STAFF RECOMMENDATION

LINCOLN MEMORIAL TEMPORARY VEHICLE SECURITY BARRIERS, EAST SIDE WASHINGTON, DC

Submission by the National Park Service

August 28, 2008

Renderings illustrating the proposed temporary barrier line across the eastern side of Lincoln Memorial Circle, at the top of the lower approachway stairs. (The illustration to the right reflects the Commission's 2007 action to rescind its prior approval of bollards descending the stairs.)

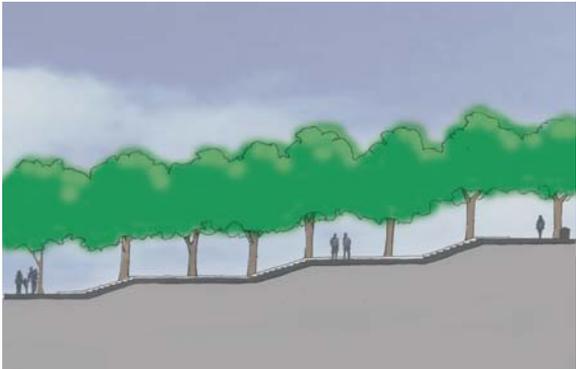
In the staff's view, NPS has successfully achieved its design objectives for the temporary barrier. Given the significance and visibility of the memorial at the western terminus of the National Mall, NPS will fabricate temporary barrier elements that have been designed specifically for the site, taking into account the warm granite of the approachway and the view and dominance of the memorial itself. The warm tones and relatively fine grain of the aggregate is intended to complement the original Milford Pink granite of the approachway. The simple massing of the blocks is intended to avoid competition with the forms of the Memorial while the refinement of the block edges and top is intended to respond to the formal monumentality of the site. At the same time, the material of the blocks is intended to indicate a temporary rather than a permanent feature.

Each block weighs approximately one ton. The blocks will be lifted into place and not attached in any way below-grade or to the surface. The adverse visual effects of the blocks will be reversed when they are removed at a future date when the comprehensive plan is implemented. The bulk of the blocks results from their weight and the fact that their strength does not derive from a below-grade connection. The 30-inch blocks (with a 32-inch finished height at the center peak) are designed and will be fabricated specifically for this site. They are markedly shorter and narrower than other temporary barriers, usually planters, customarily used at other locations. Given the significance of the memorial and its Mall setting, the visibility of the barrier blocks, and the uncertainty about the timeframe for their presence at the site, an appropriately designed temporary solution is necessary. Staff commends the Park Service for a barrier design that is suitable for the memorial as a temporary measure and that will be completely reversible in future because it will not cause an alteration of the original granite.

Approves preliminary and final site development plans for a temporary vehicle barrier across the lower approachway at the center of the east side of Lincoln Memorial Circle, as shown on NCPC Map File No. 1.44(38.40)42594, for a period not exceeding two years, consistent with the Commission's approval of temporary physical security measures.
